METROPOLITAN GOVERNMENT OF NASHVILLE AND DAVIDSON COUNTY

STAFF RECOMMENDATION 2121 Westwood Avenue September 18, 2019

Application: New Construction—Addition; Setback Determination; Partial Demolition
District: Hillsboro-West End Neighborhood Conservation Zoning Overlay
Council District: 18
Base Zoning: RS7.5
Map and Parcel Number: 10415039900
Applicant: Blaine Bonadies
Project Lead: Melissa Baldock, melissa.baldock@nashville.gov

Figure 3. Parcel Map showing 2121 Westwood Avenue's deep front setback.

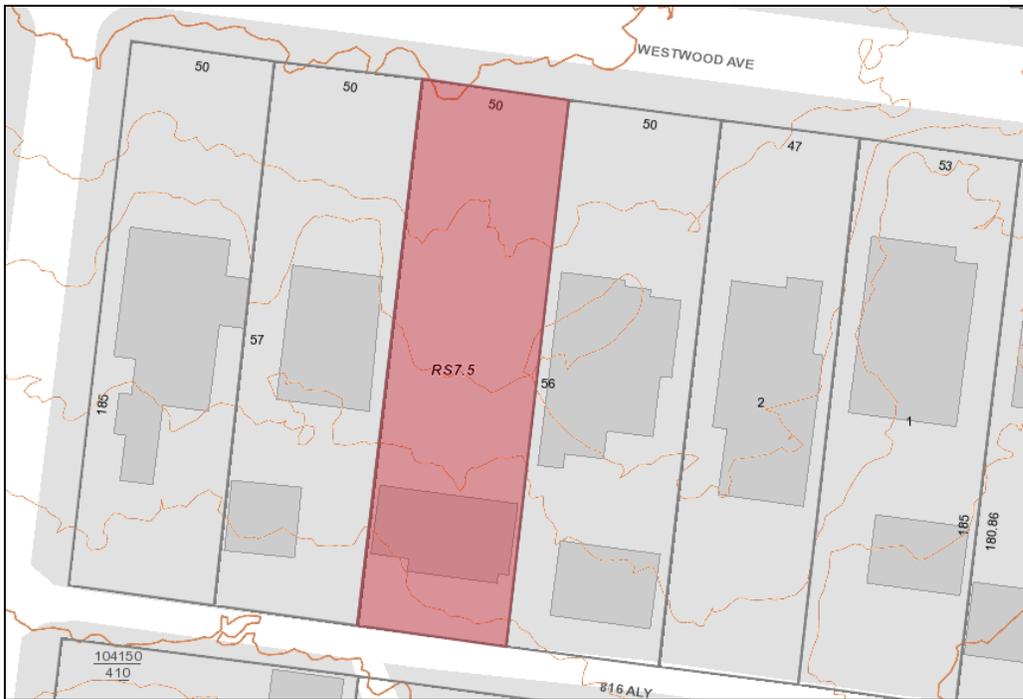
Background: 2121 Westwood Avenue was constructed c. 1926 at the back of the lot (Figures 1, 2, and 3). The building is listed as a contributing resource to the Hillsboro-West End National Register of Historic Places Historic District, and it contributes to the historic character of the Hillsboro-West End Neighborhood Conservation Zoning Overlay.

Figures 4 & 5. The rear shed roof portion of the house will be removed.

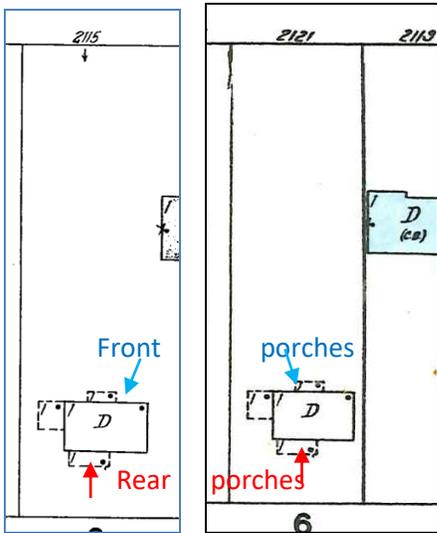
Demolition: The applicant intends to remove a non-historic rear portion of the house (Figures 4 & 5). The Sanborn maps show that there once was an enclosed porch at the rear, but the dimensions are different than the dimensions of the rear shed roof area that exists today. Staff finds that the removal of this rear portion of the historic house is appropriate because the rear appendage does not contribute to the historic character of the house. Its removal will not detrimentally alter the historic house's historic and architectural character.

Figure 9 (left) is the Sanborn map, where the porch is approximately 10'-12' wide and 4'-6' deep. Figure 10 (right) is the proposed plan showing a porch that is 15'1" wide and 12'4" deep.

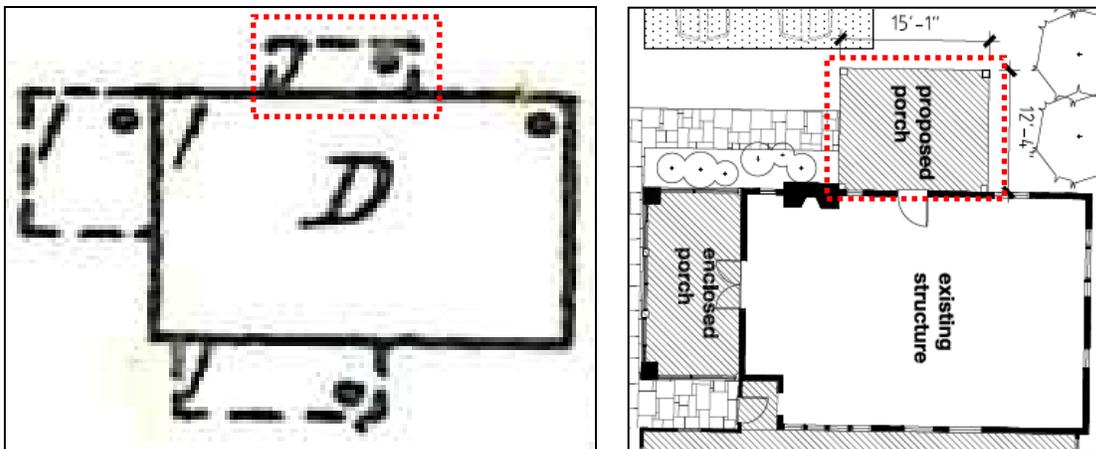
The Sanborn maps are at a one/one hundredth scale (1"=100'). Using this small scale, staff estimates that the former front porch on the house was between ten and twelve feet (10'-12') wide and four to six feet (4'-6') deep (Figure 9). By contrast, the applicant is proposing a new front porch that will be fifteen feet, one inch (15'1") wide and twelve feet, four inches (12'4") deep (Figure 10). Comparing the Sanborn map to the plan of the proposed porch shows how the proportions of the proposed porch do not match what was there historically.

Staff unfortunately does not have an images of what the porch looked like historically. The roof form and column design are unknown, and as such, the applicant has some leeway in the design of the recreated front porch. That said, the general dimensions and scale of the front porch are known from the Sanborn maps, and staff recommends not deviating from them. The Sanborn map clearly shows a modest front porch with a shallow depth. What is proposed introduces a new porch scale that is not based on the documentation available, namely the Sanborn maps. If a new architectural feature is to be reintroduced to the front of the house, the feature should follow, to the closest approximation, the historic conditions and measurements, to the extent that they can be known. For that reason, staff finds that the footprint of the porch, as proposed, is too large. Staff recommends that the footprint of the front porch be reduced so that it is no deeper than six feet (6') and no wider than twelve feet (12').

With the condition that the footprint of the front porch be reduced to be no wider than twelve feet (12') and no deeper than six feet (6'), staff finds that the proposed front porch addition meets Sections II.B.1.a., II.B.1.b., and II.B.2. of the design guidelines.

2121 WESTWOOD AVE

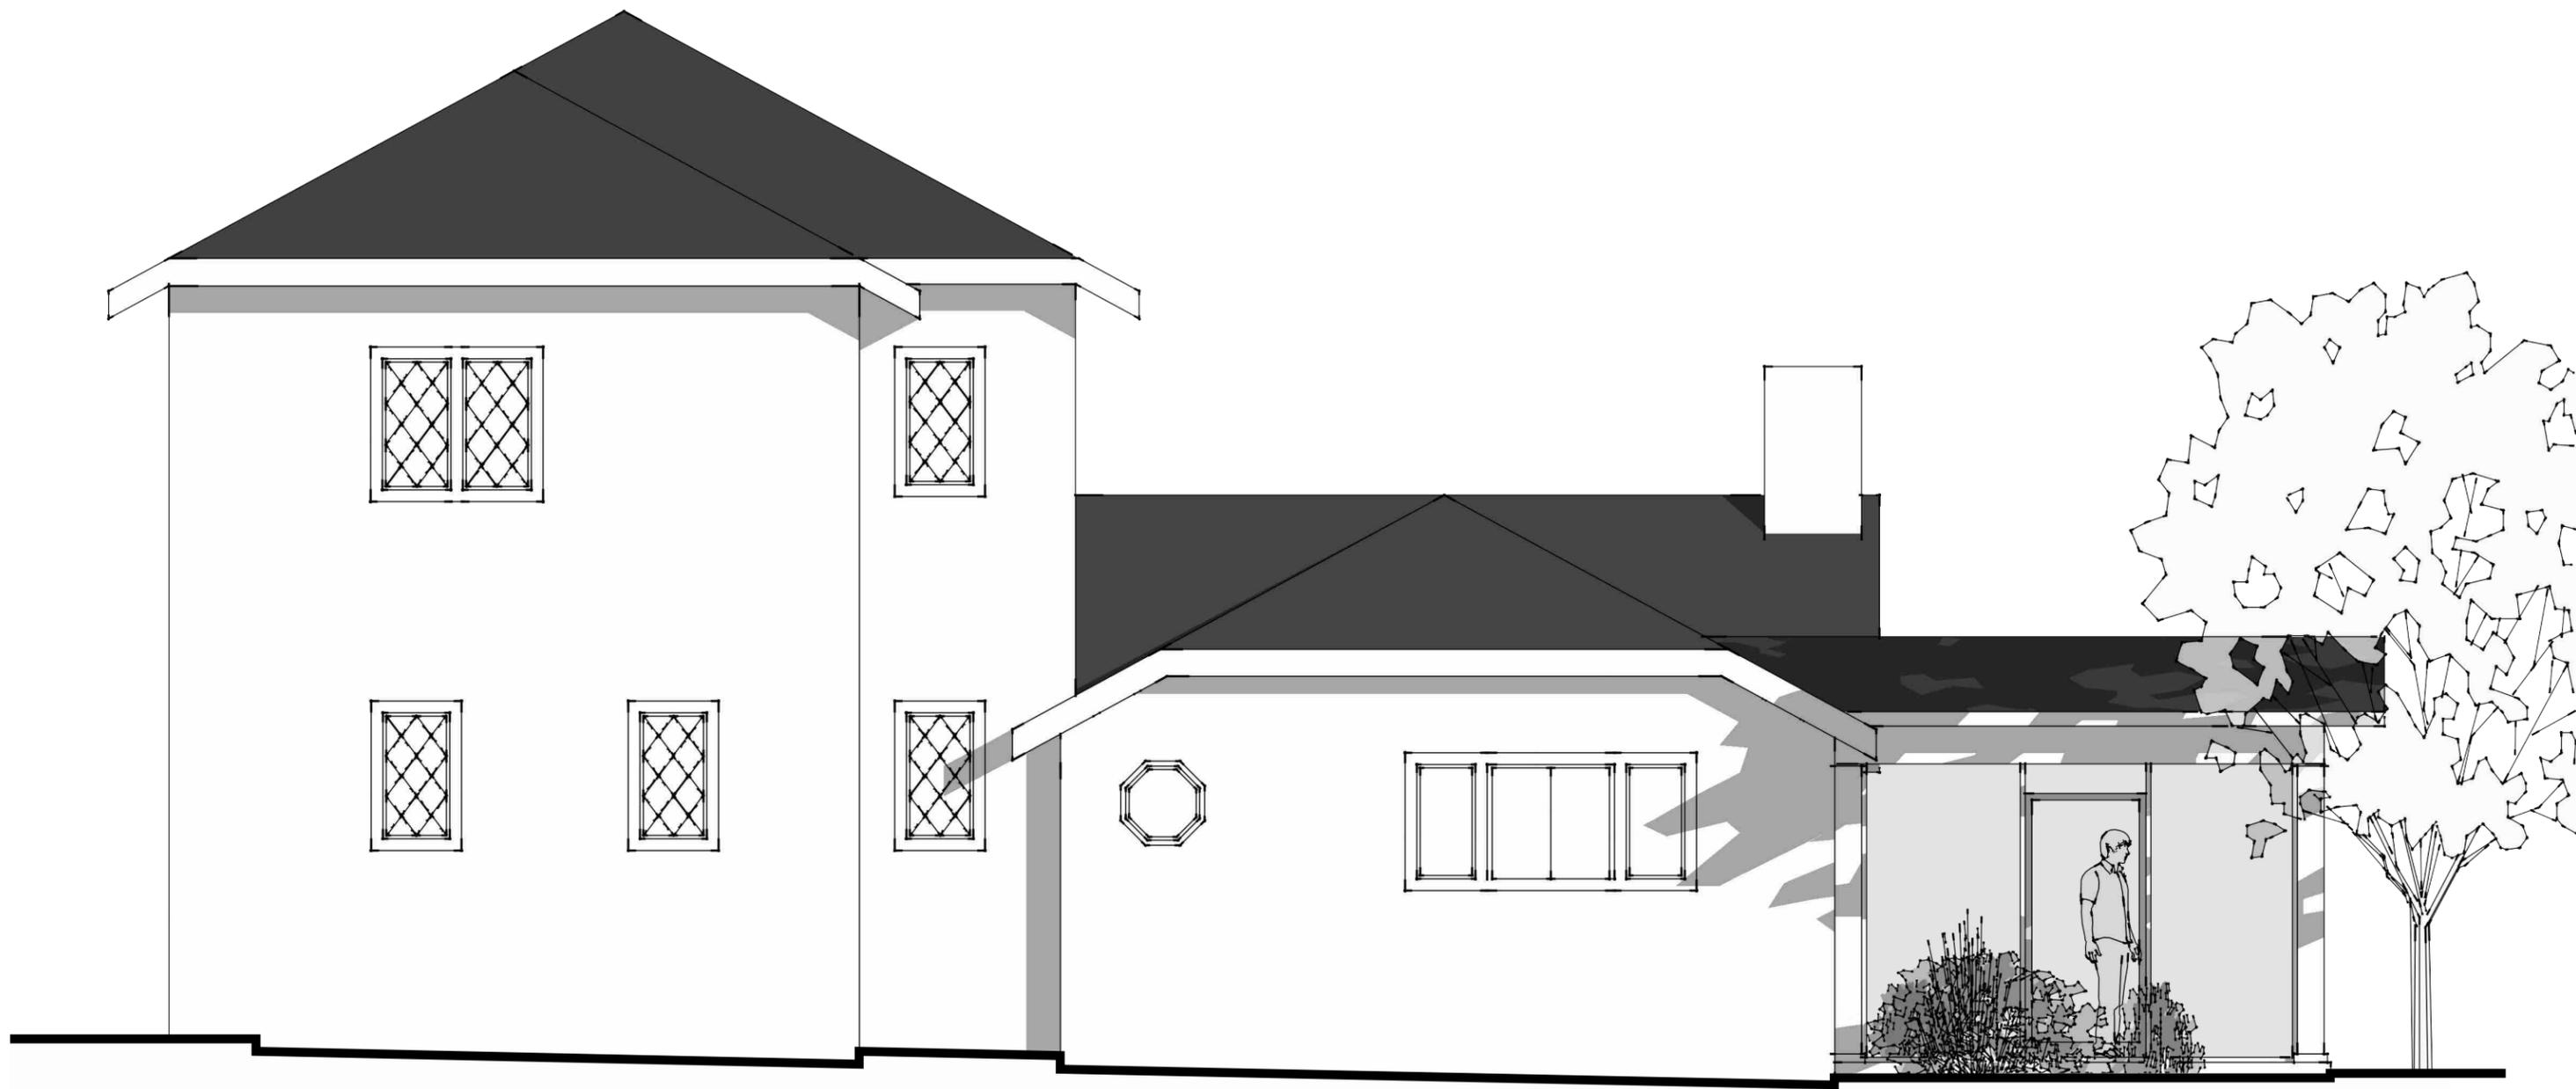
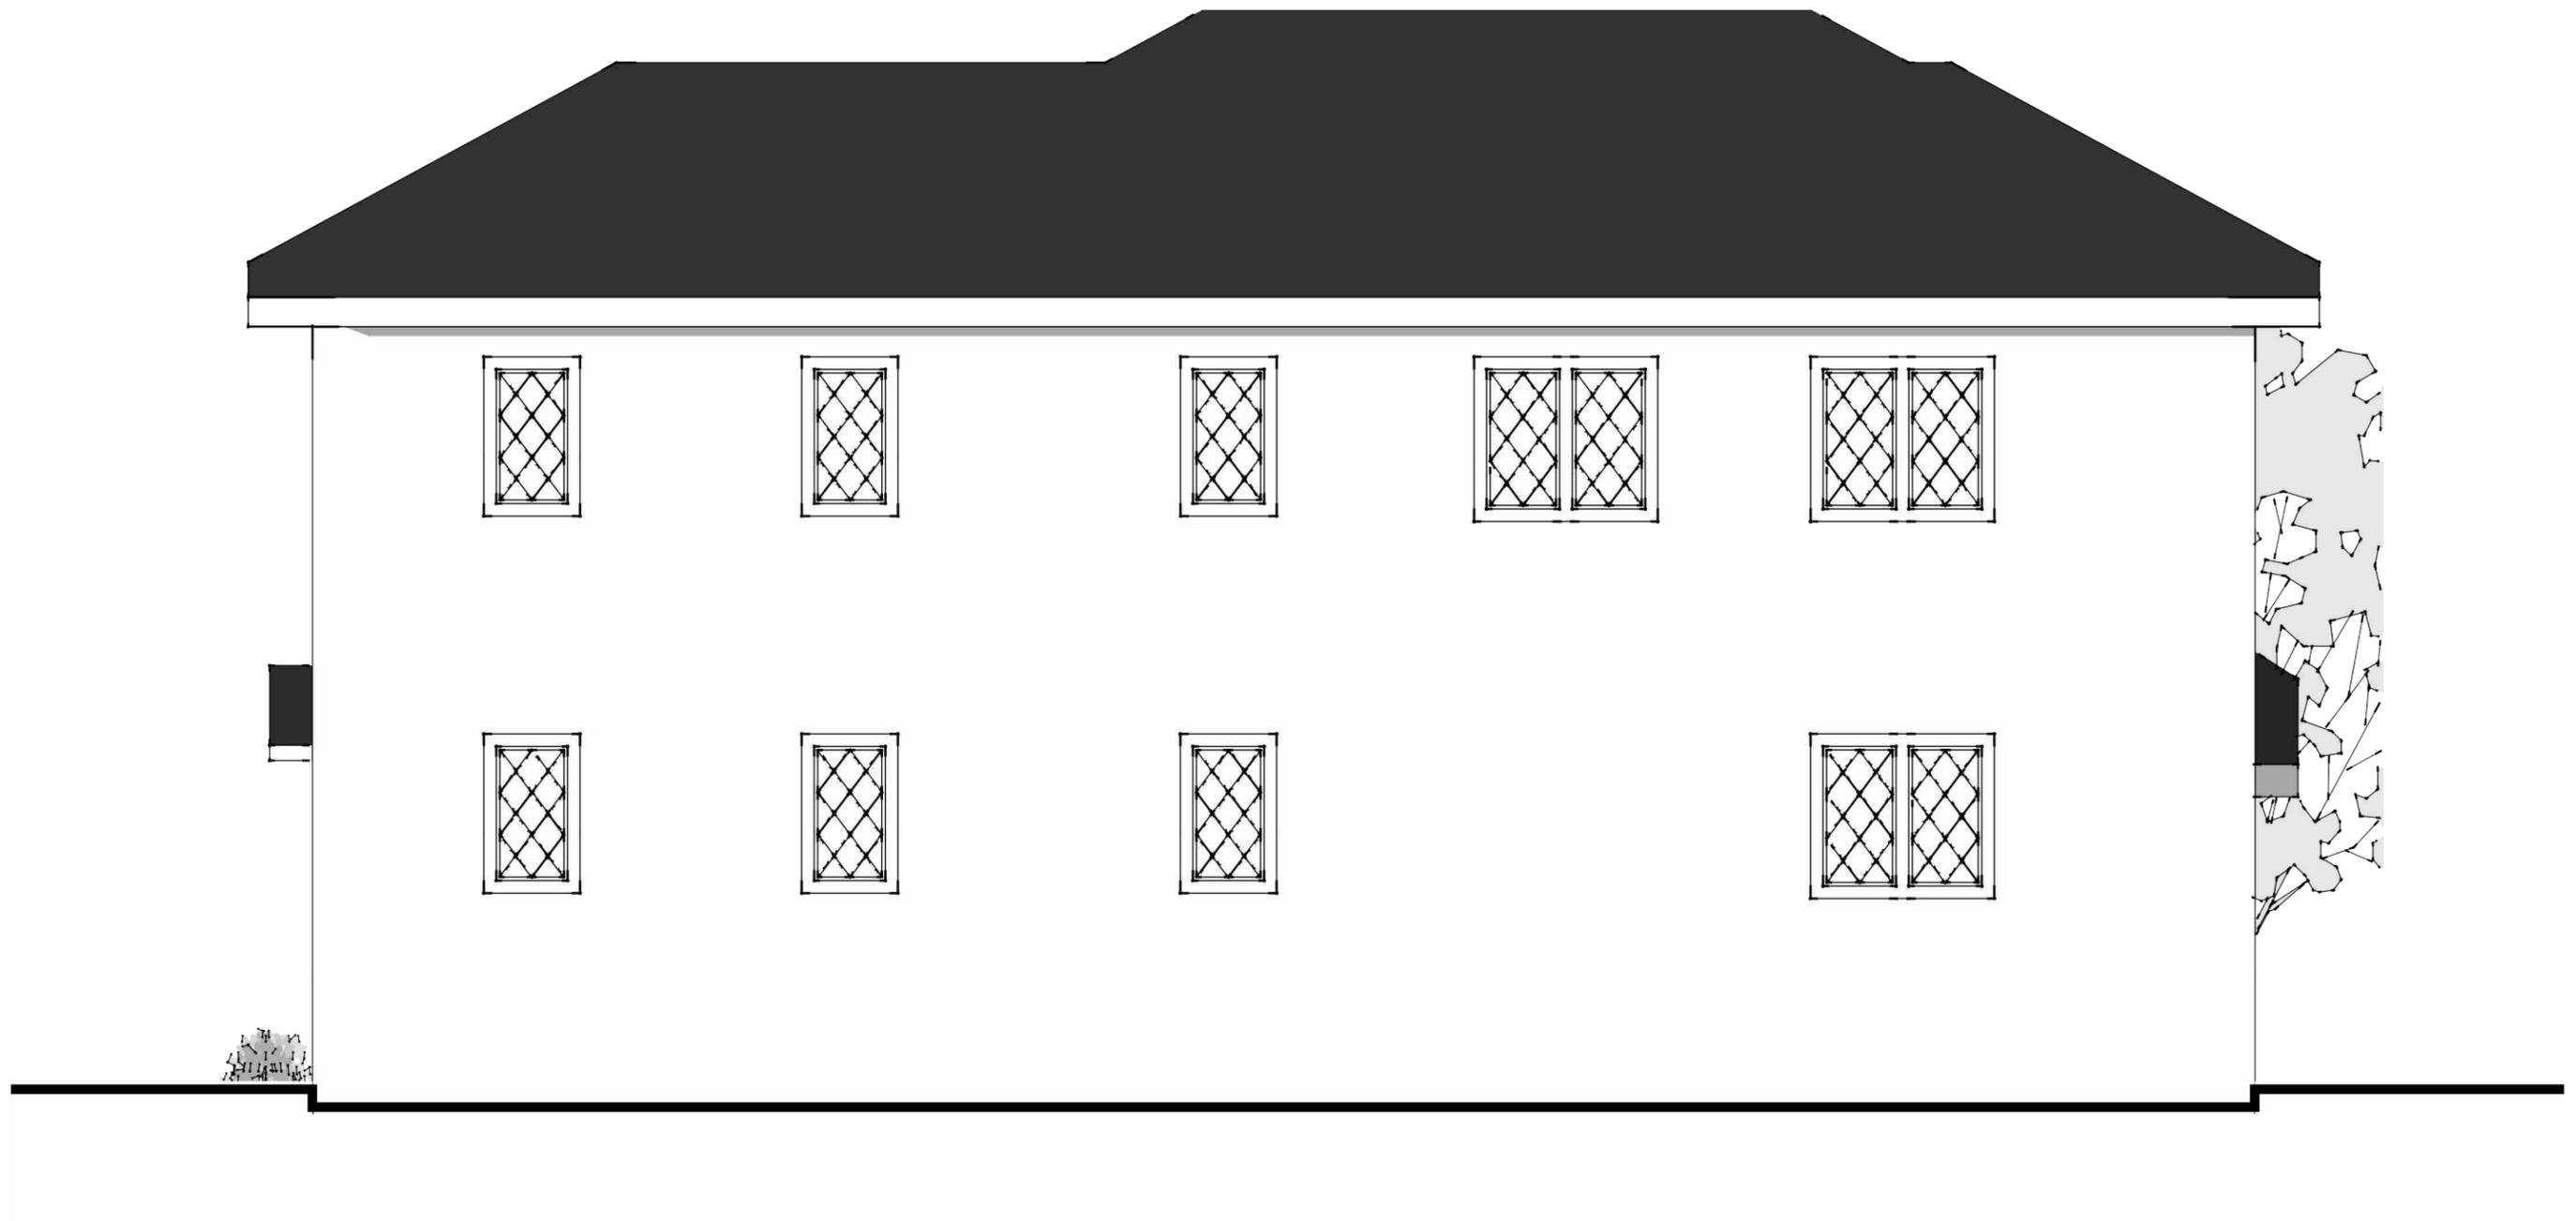
Rear Addition Height and Scale: The rear addition will be a two-story form behind a one-story house. The addition will be twelve feet (12') taller than the historic house. Although the design guidelines state that additions can be up to four feet (4') taller when being taller is the only option, staff finds that a two story addition that is twelve feet (12') taller could be appropriate here because of the constraints of this lot. With just twenty feet (20') of rear yard space, there is not much room to add square footage to the lot at the rear. A two-story addition provides the best way to add needed square footage while preserving the historic house. The design of the rear addition does preserve the overall roof form of the historic house. That said, staff does recommend two changes to the scale of the house to bring it more into compliance with the design guidelines and the scale of the house.

Second, staff recommends that the two-story portion of the addition not extend behind the side porch/porch cochere, the lowest and most open portion of the existing the house. Staff recommends any addition behind the side porch/porte cochere be one-story in height (Figures 11 & 12). This will help to keep the scale of the addition from further overwhelming the scale of the historic house.

With the conditions that the rear addition be at least five feet (5') from the rear property line and the section of the addition behind the side porch/porte cochere be one-story in height, staff finds that the rear addition's height and scale to meet Sections II.B.1.a., II.B.1.b., and II.B.2. of the design guidelines.
